sensei™

Technical Notice

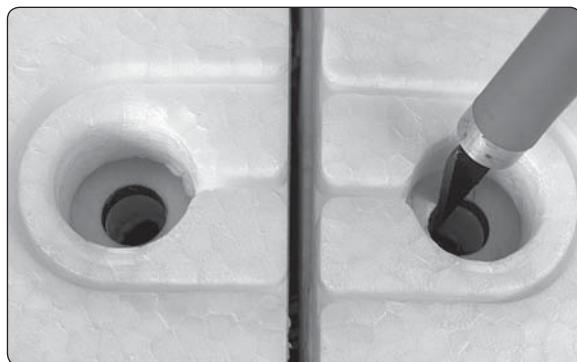
The fit between the two wing panels of the Sensei Trainer is exceptionally snug. Follow the instructions on page 8, step 3 by inserting the plastic wing connector into the top of the wing. If the wing connector will not easily slide into the aligned holes in the wing and wing joiner, you'll need to follow these steps to ensure a proper fit.

1. Inspect both holes in the location where the wing connector should be installed. Look for misalignment between the white plastic holes in the wing joiner and the holes in the plywood inserts installed in the wing.

2. Use a marker to highlight the excess areas of the plywood which restrict the wing connector fit.

3. Separate the wing panels and remove the joiner.

4. Use a #11 blade to remove excess plywood material which is causing the misalignment from one or both plywood inserts.
